Issue	**1**
Factory ID	**25514**
Date of Issue	**18-Jun-2026**

TAJ Industries

Structural Safety Inspection Report

Pakistan Accord Initial Safety Inspection Report

Figure 2.1 - Location of stressed columns (yellow) and highly stressed columns (amber)

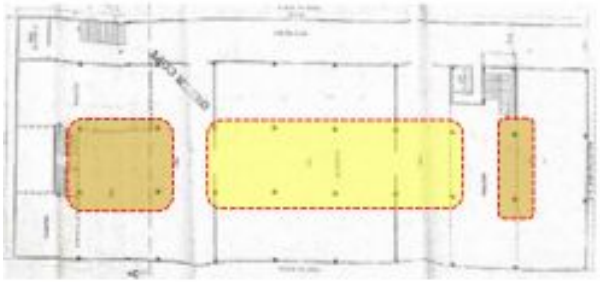
Based on the initial assessment and considering the observed loading conditions, the internal RC columns at ground floor level of the main building appear to be highly stressed, likely attributed to the relatively large structural grid (7.64 m × 5.9 m) and unavailibility of concrete strength data. F-202604-065622

Timeline	Remediation Plan
Immediate CAP-0077868	Verify insitu reinforcement by removing cover and confirming no. and diameter of bars and submit results to Pakistan Accord.
Immediate CAP-0077869	Verify in-situ concrete strength for the identified columns either by 100mm dia. cores from at least 4 columns or existing cylinder strength data and submit results to Pakistan Accord.
Immediate CAP-0077870	Verify strength of reinforcement through laboratory tensile strength testing.
Immediate CAP-0077871	(1) Appoint qualified and competent Structural Engineer to carry out DEA on the full building , in accordance with the DEA scope and minimum requirements set out in the Initial Inspection report.
Medium Term CAP-0077872	Factory Engineer to review design, loads and columns stresses in area identified and submit to Pakistan Accord for review.
Medium Term CAP-0077873	(2) Submit accurate As-built Drawings showing structure, loading, elements, dimensions, levels, foundations and framing on Plan, Section and Elevation drawings and a report on Engineering tests carried out to justify material strengths and reinforcement content in all key elements studied, to Pakistan Accord for review

Medium Term CAP-0077874	(3) Submit structural engineering assessment with supporting calculations based on the as-built drawing and material strengths along with safe load plans reviewed previously using a model-based design that justifies the safety and serviceability of the building against loading as set out in Building Code of Pakistan

Medium Term CAP-0077875	(4) Submit proposals for any retrofitting works that may be needed to demonstrate the adequacy of the structure to Pakistan Accord for review
Longer Term CAP-0077876	(5) Carry out all retrofitting works if needed as proposed and previously reviewed by Pakistan Accord
Longer Term CAP-0077877	(6) Factory to advise Pakistan Accord when all retrofitting works are complete and make provision for a verification inspection attended by the factory Structural Engineer. Once Pakistan Accord has verified retrofitting works in accordance with previously reviewed proposals, then this item will be complete.
Longer Term CAP-0077878	Continue to implement load plan

Figure 2.2 - Location of steel emergency staircase

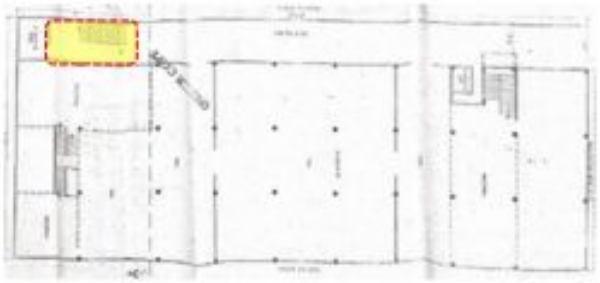
This observation relates to the steel emergency staircase of the main building. At each level, the stair flight members are found to be bearing on undersized landing members. Additionally, a portion of these members remains unwelded/unconnected, resulting in inadequate load transfer and increased structural vulnerability. F-202604-065627

Timeline	Remediation Plan
Medium Term CAP-0077861	Building structural engineer to review the as-built design for code compliance and confirm if the connection details is adequate and submit the report with remedial measures to Pakistan Accord for review.
Longer Term CAP-0080629	Implement the required remedial works

Figure 2.6 - Location of exposed column rebars at roof

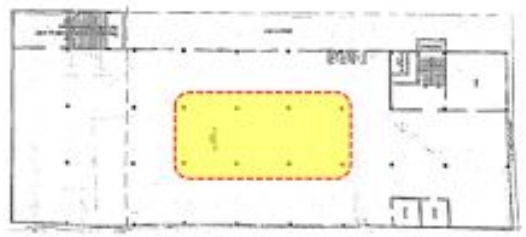
This observation relates to the roof level of the main building, where column reinforcement bars are exposed, posing a high risk of corrosion due to direct exposure to environmental conditions. F-202604-065631

Timeline	Remediation Plan
Medium Term CAP-0077895	Building Engineer to inspect areas with protect the exposed rebars from the weather and to propose the remedial solution to further stop reduce the effect of corrosion.
Longer Term CAP-0077896	Implement the remedial works.
